2	11/26/25	ADD SCD RM-3.1

BRIDGE NO. CUY-77-15.46
IR 77 OVER WOODLAND AVE.

ESTIMATED QUANTITIES
BRIDGE NO. CUY-77-15.46
IR 77 OVER WOODLAND AVE.

GENERAL PLAN
BRIDGE NO. CUY-77-15.62
IR 77 OVER E. 22ND ST.

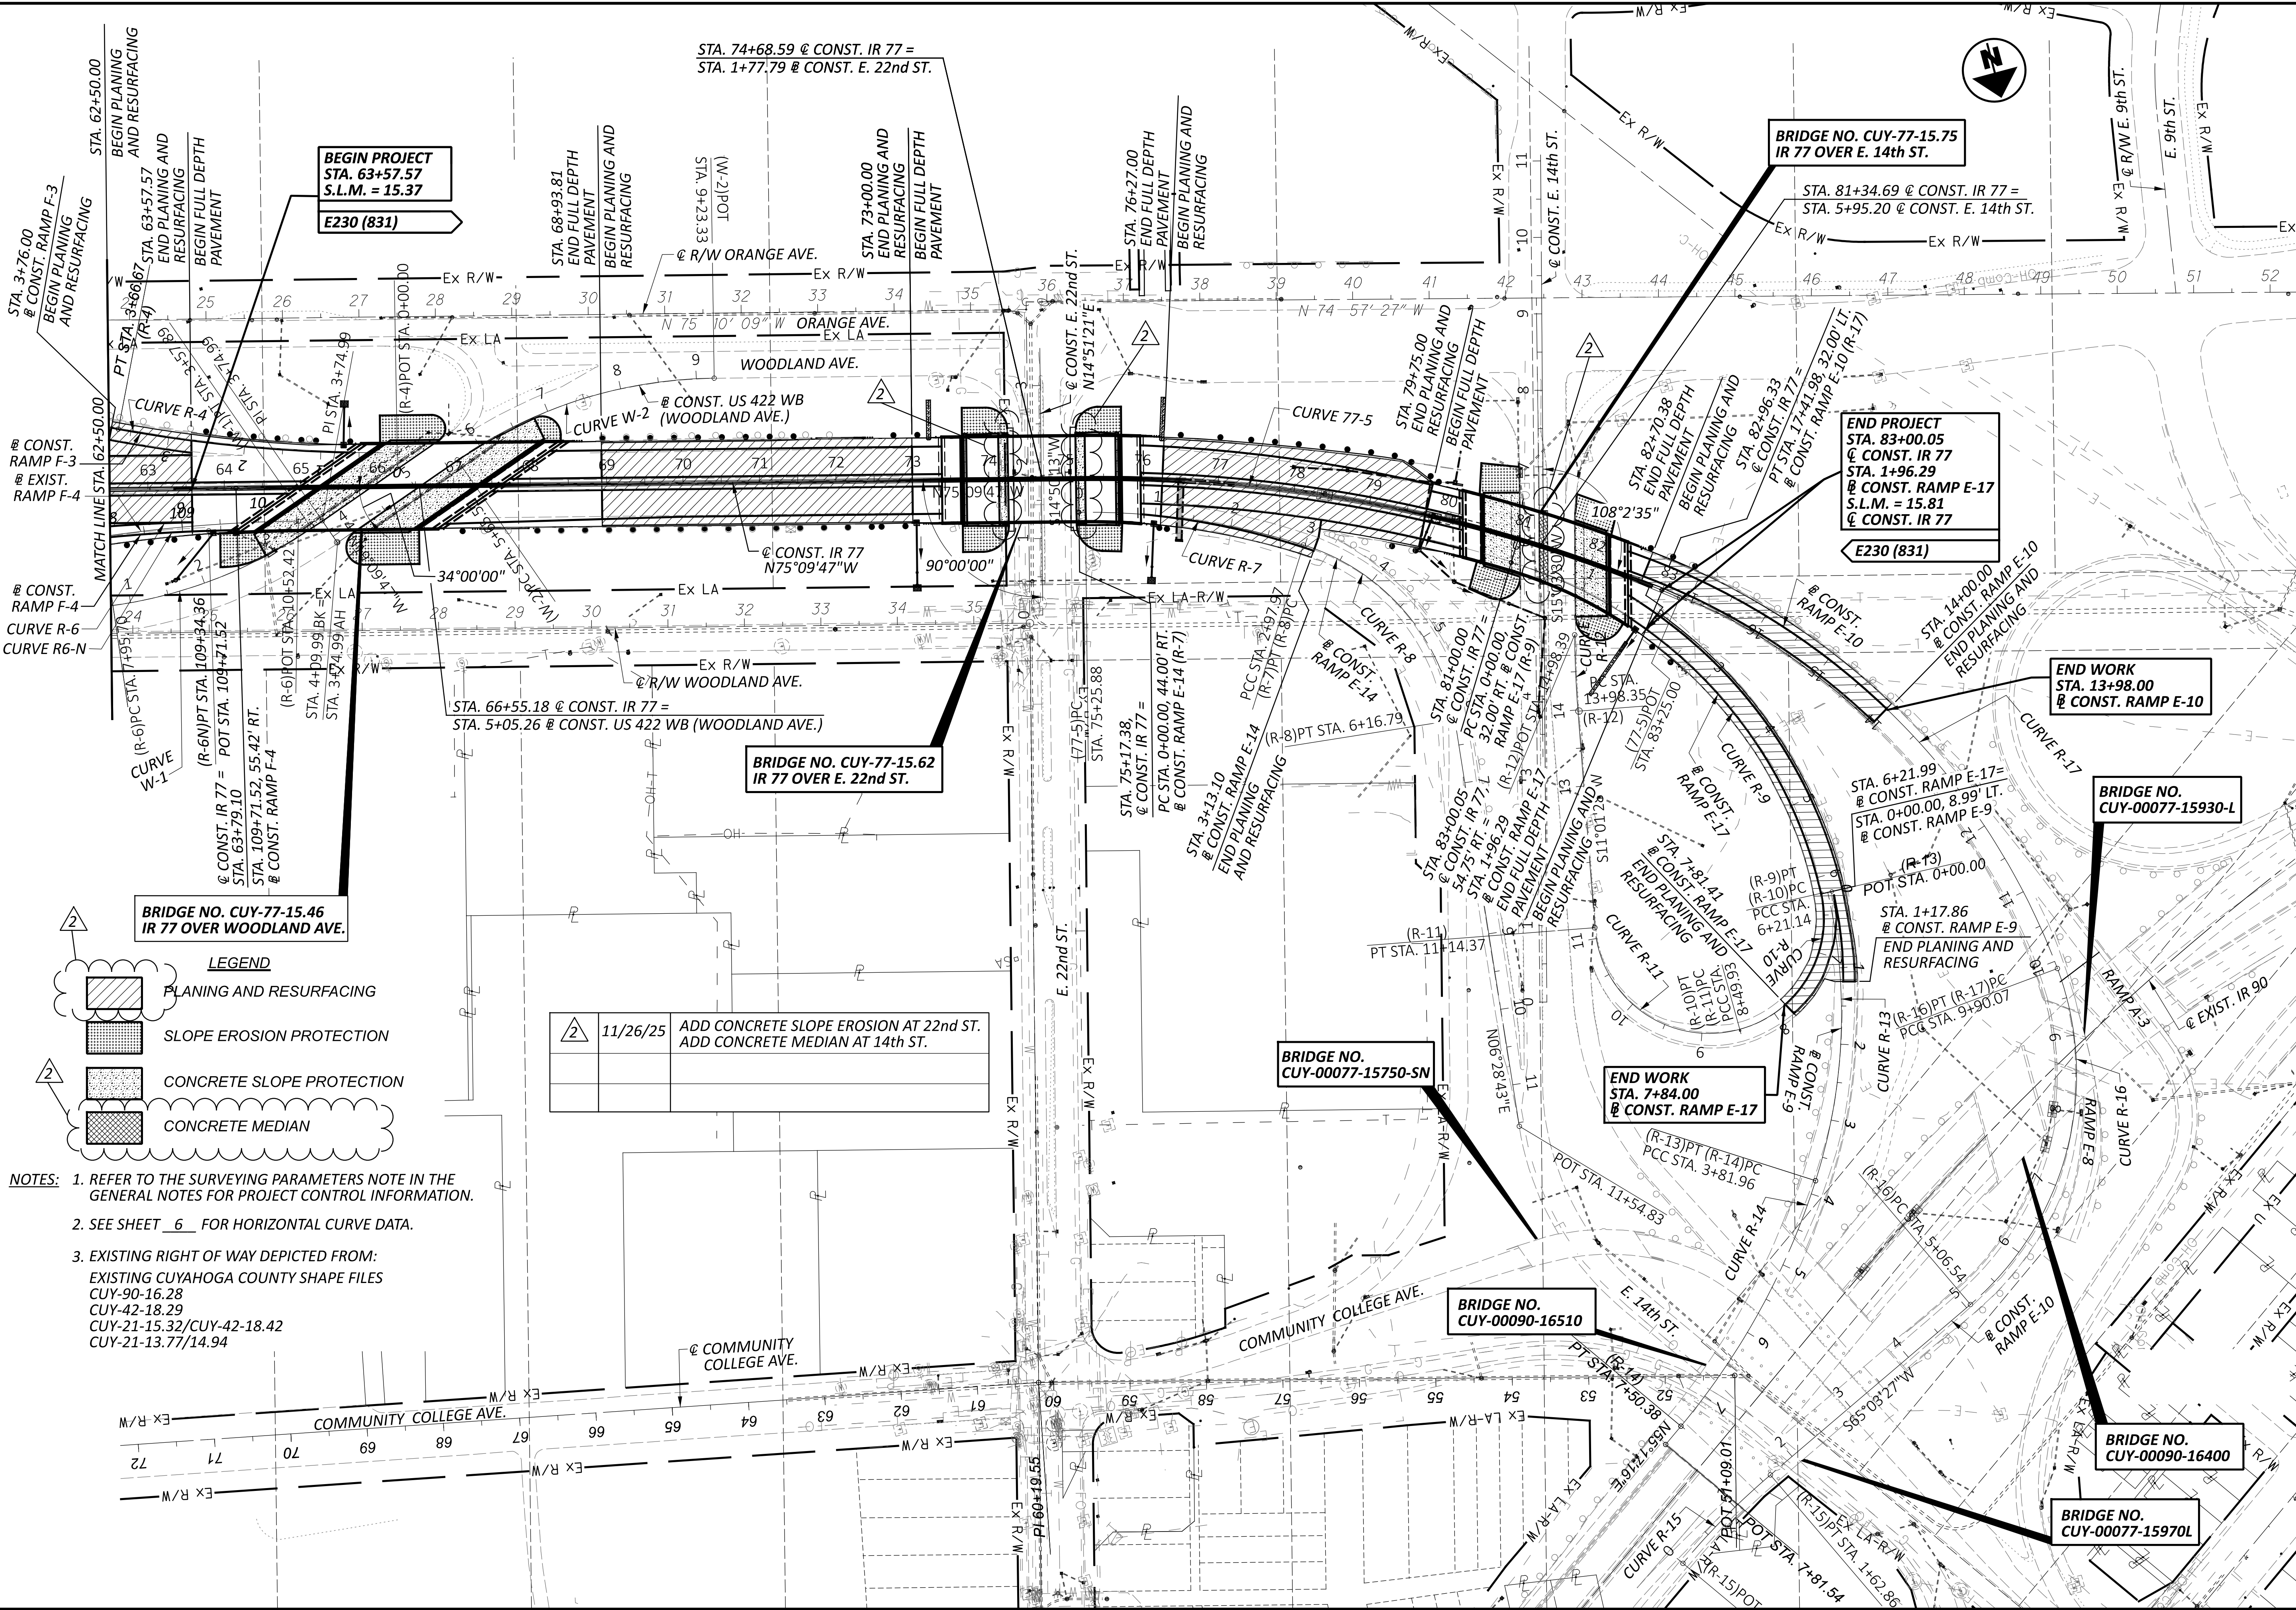
11/26/25	ADD CONCRETE SLOPE EROSION AT 22nd ST. ADD CONCRETE MEDIAN AT 14th ST.

MAINTENANCE OF TRAFFIC PLAN - SB PHASE 2
(NB MOT 1B)
STA. 72+50.00 TO STA. 4+00.00

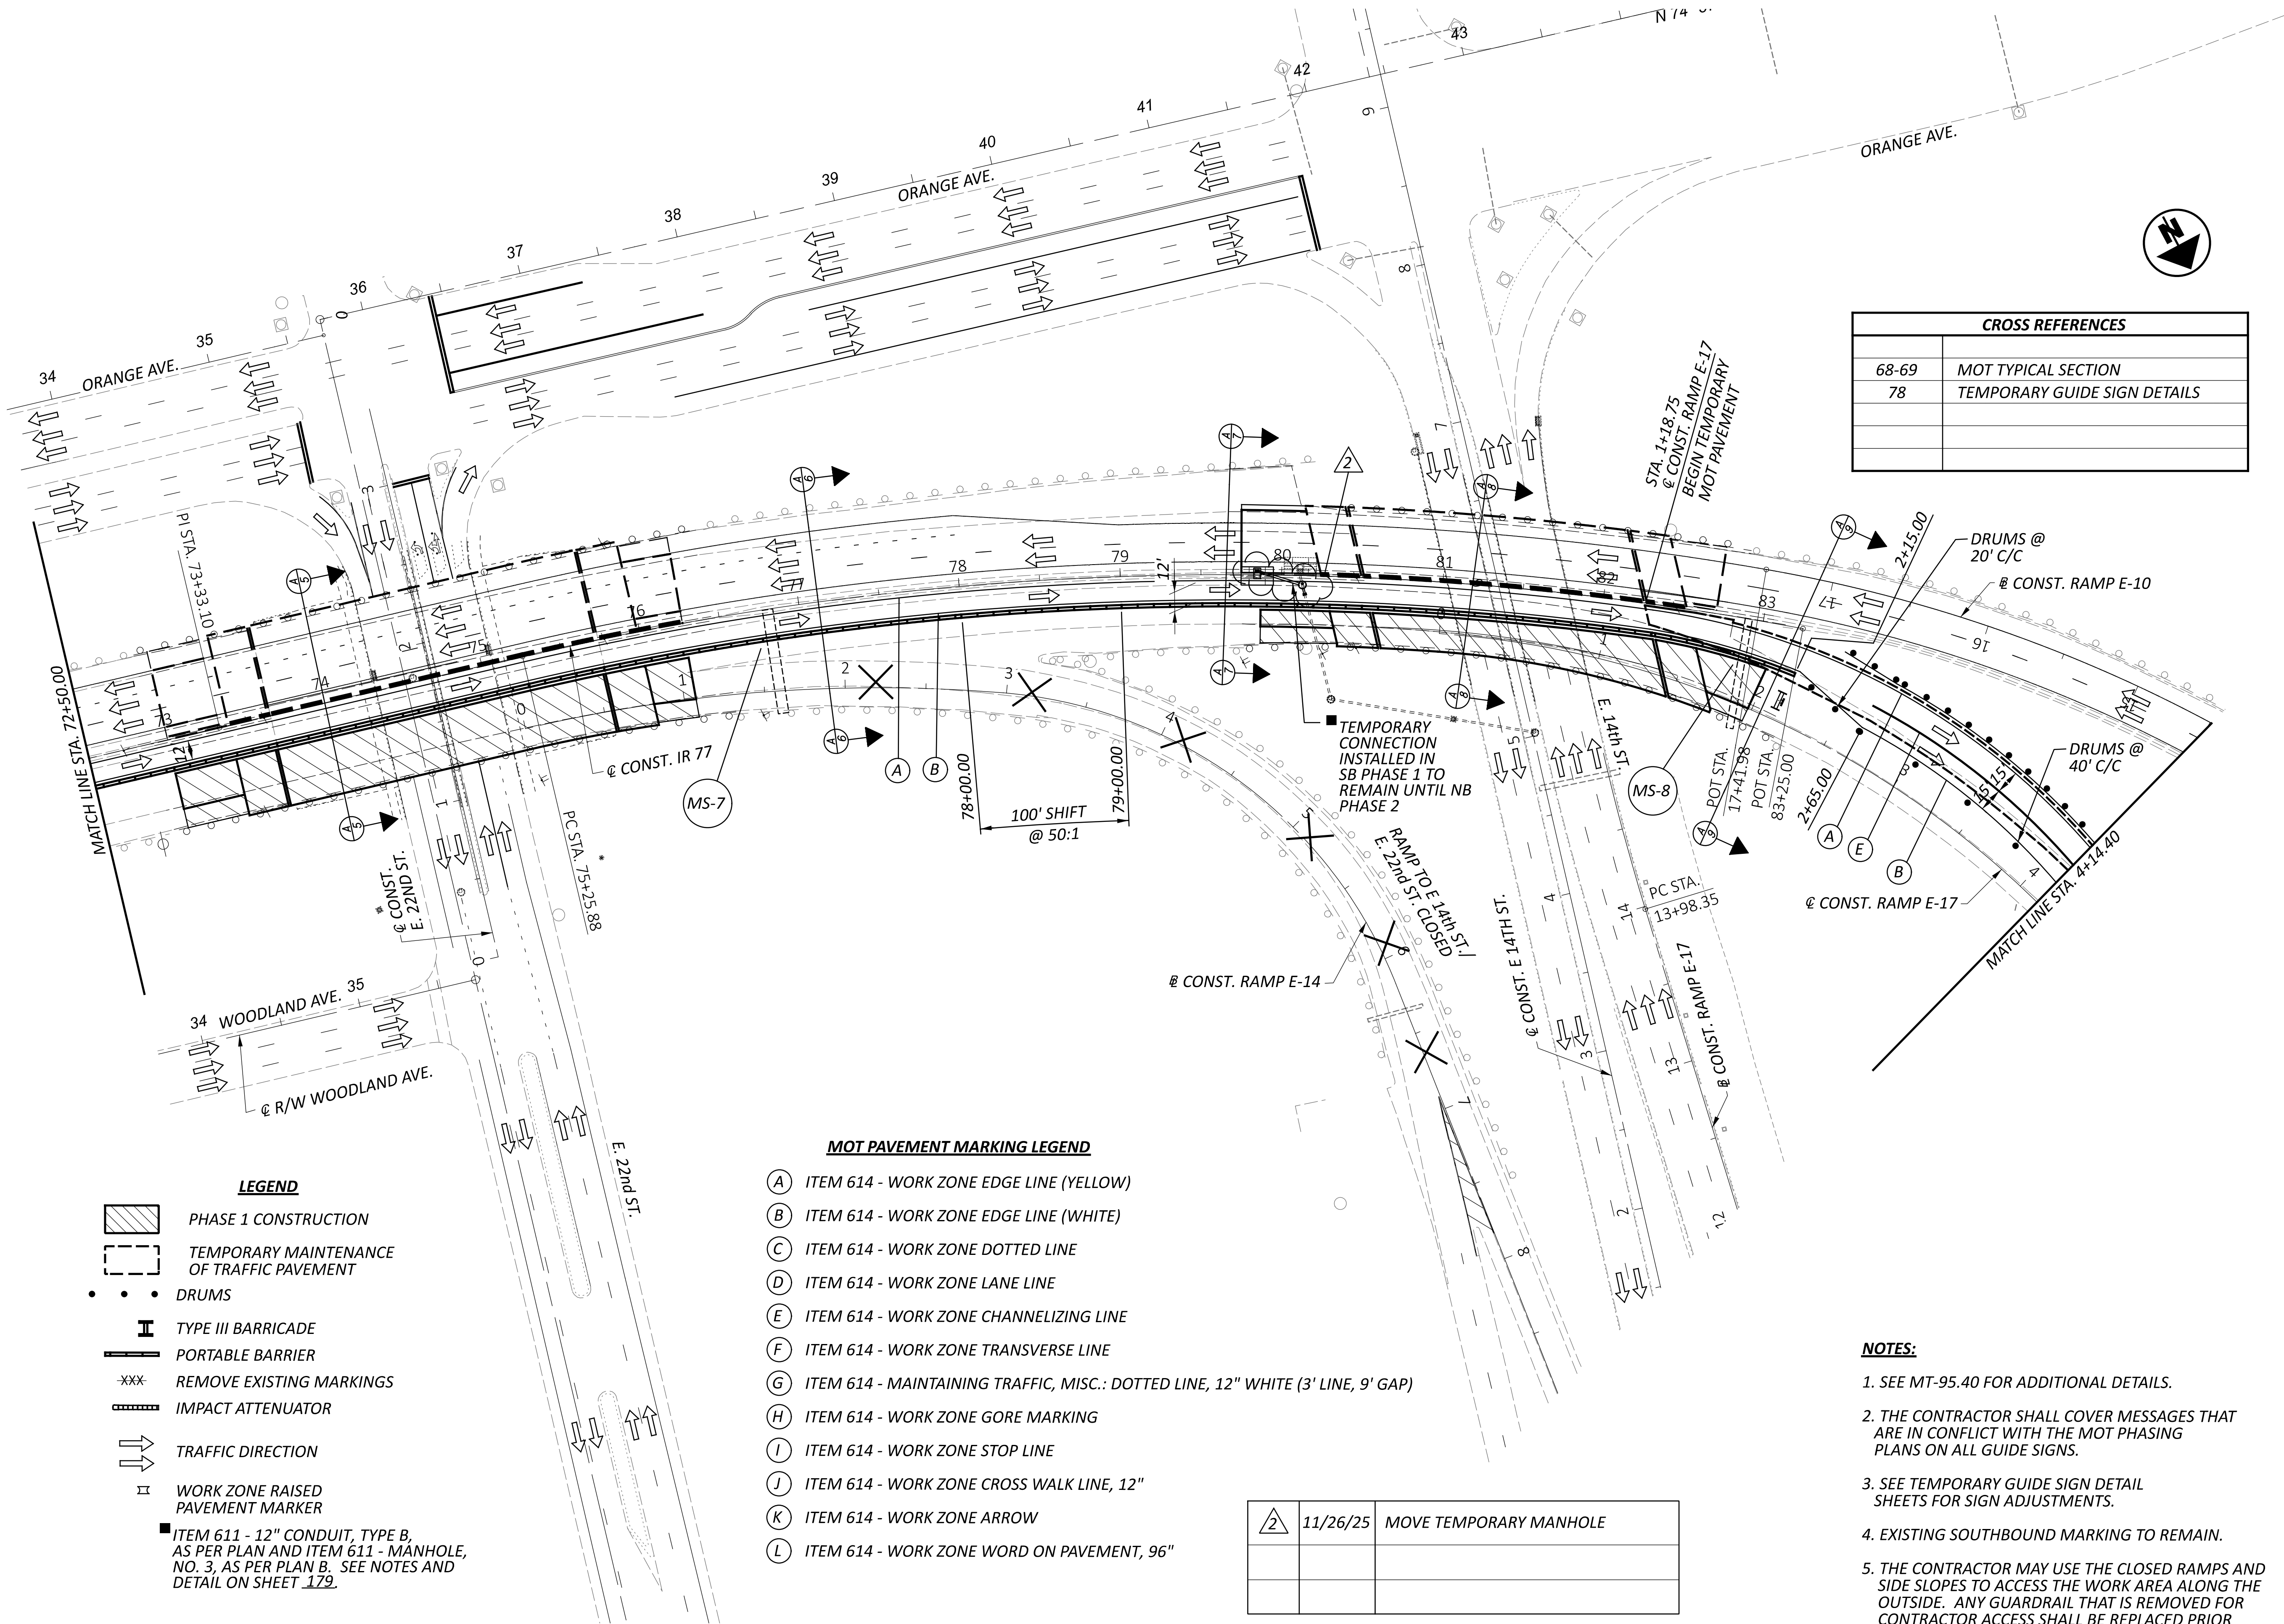
11/26/25	MOVE TEMPORARY MANHOLE

IR 77 PLAN
STA. 72+50.00 TO STA. 81+00.00/STA. 0+00.00 TO STA. 4+00.00

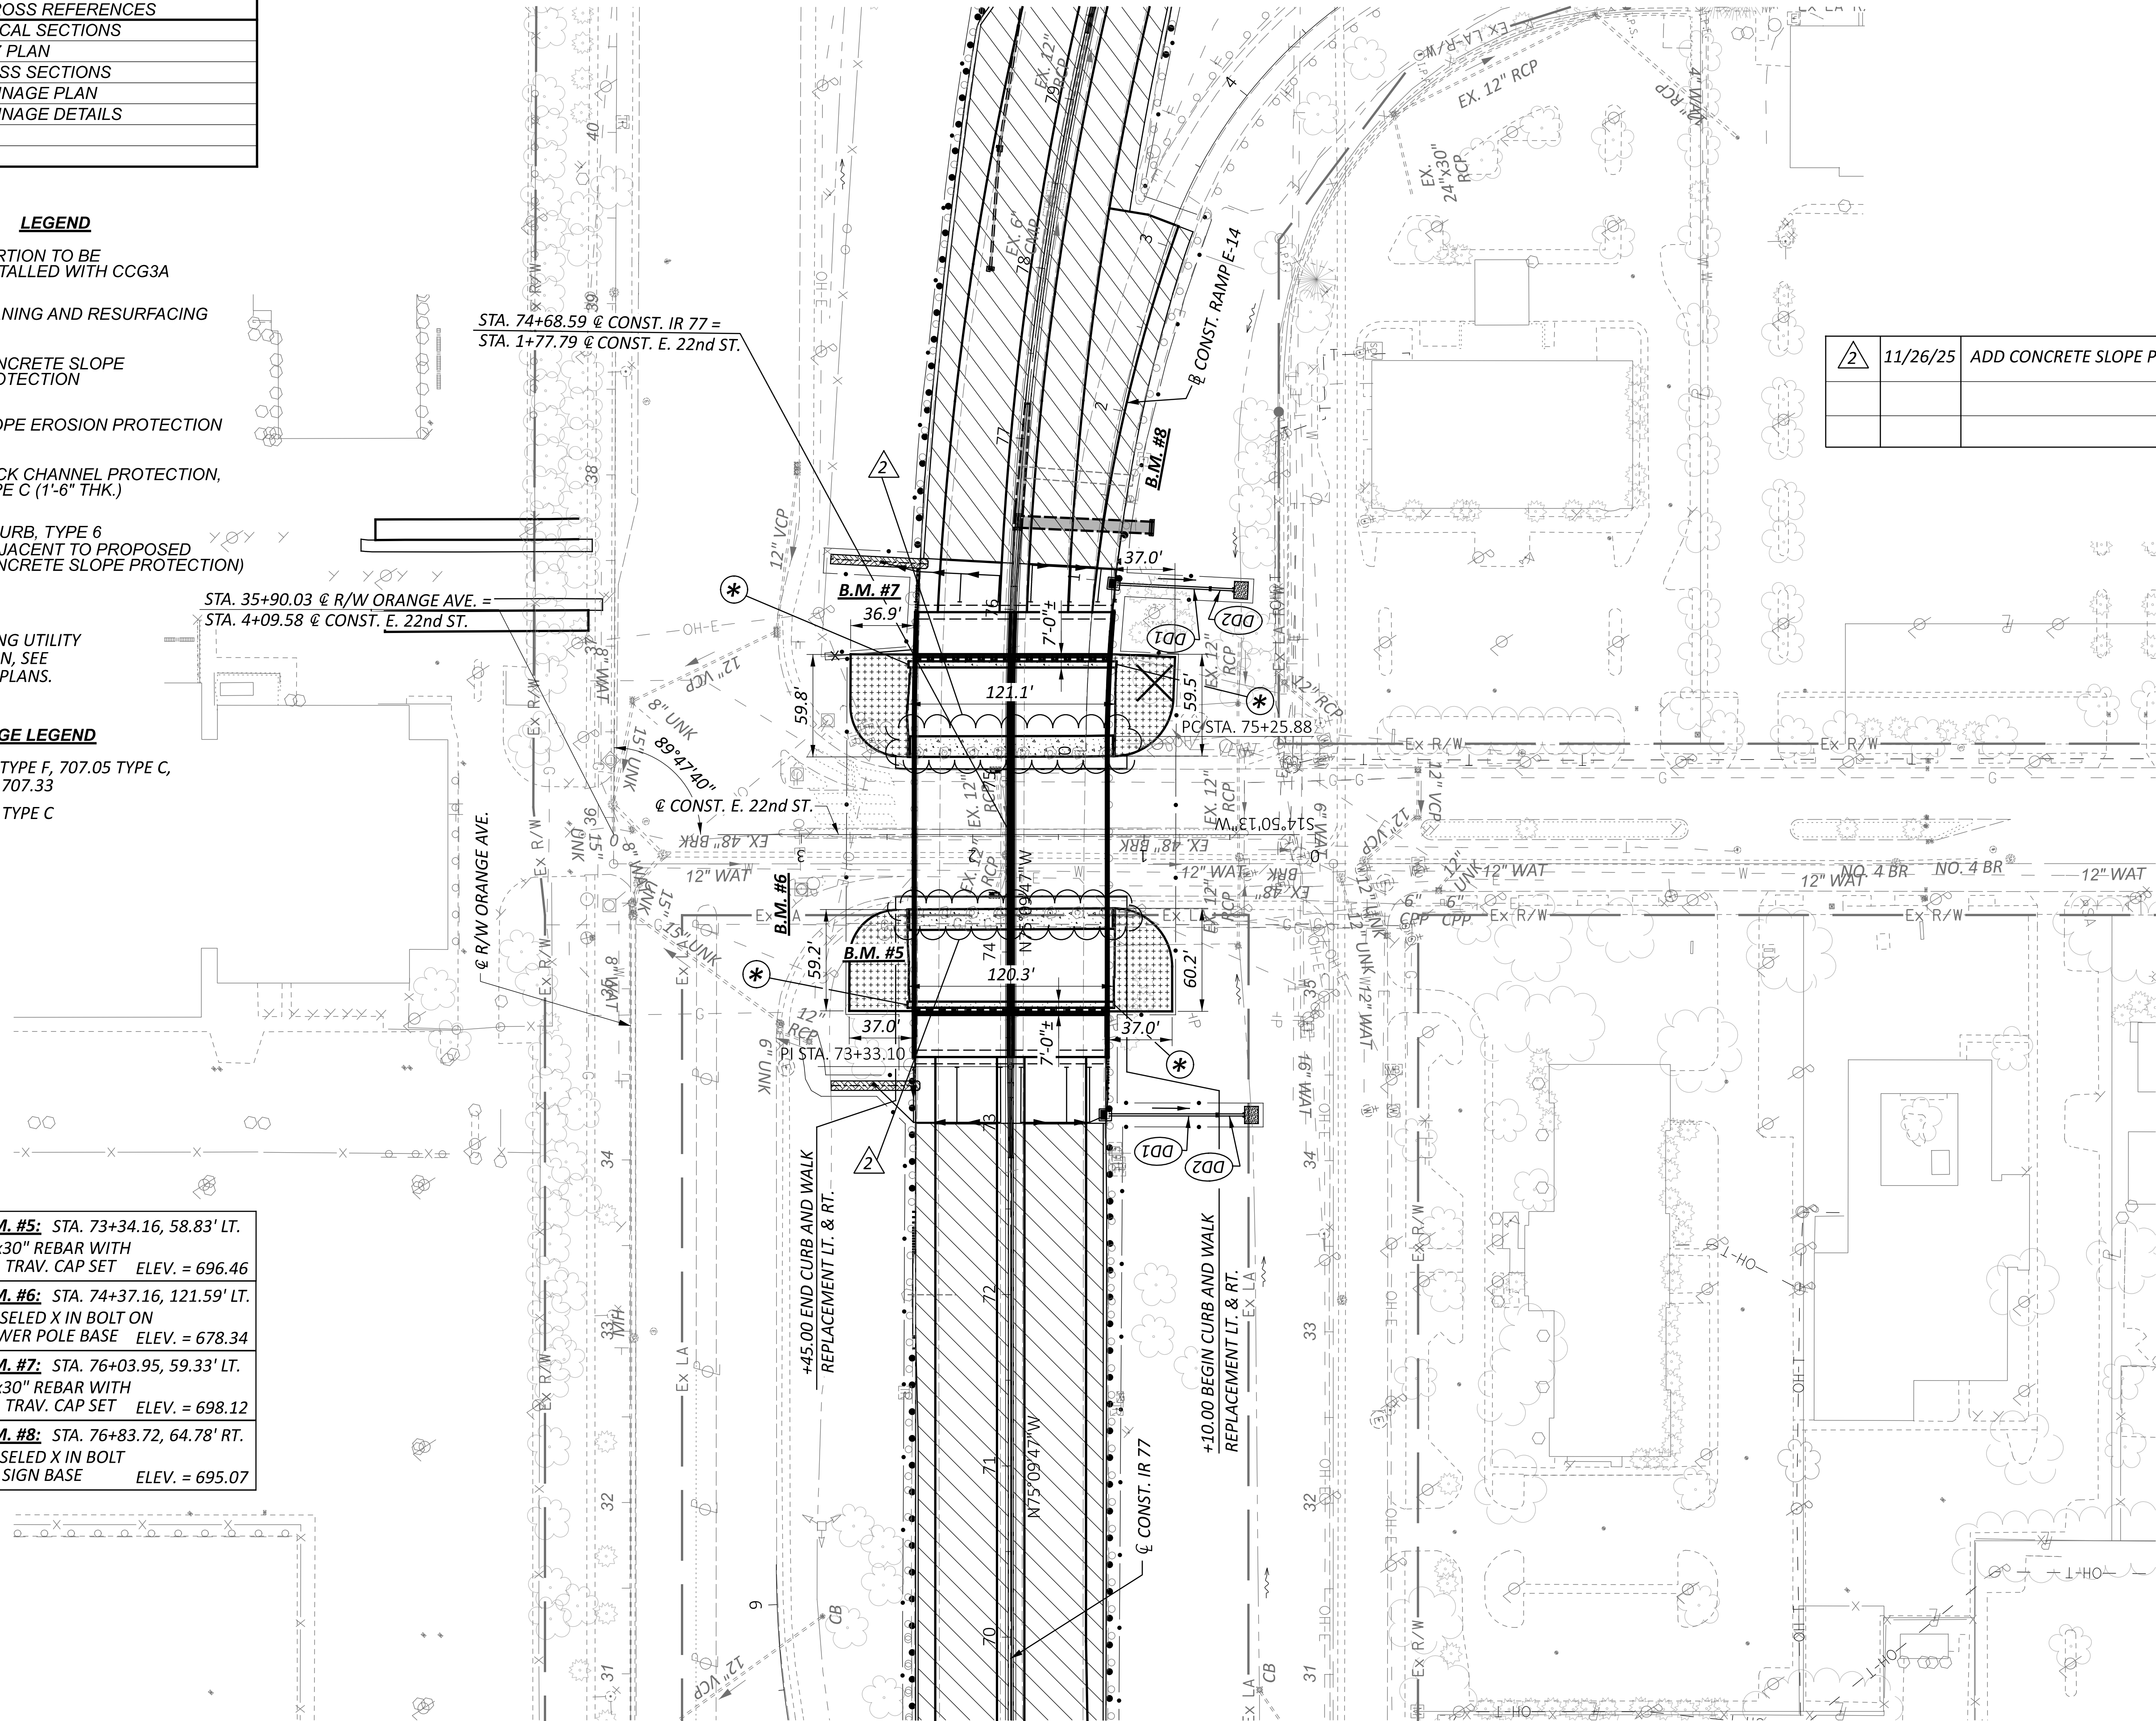
2	11/26/25	ADD CONCRETE MEDIAN AT 14th ST.
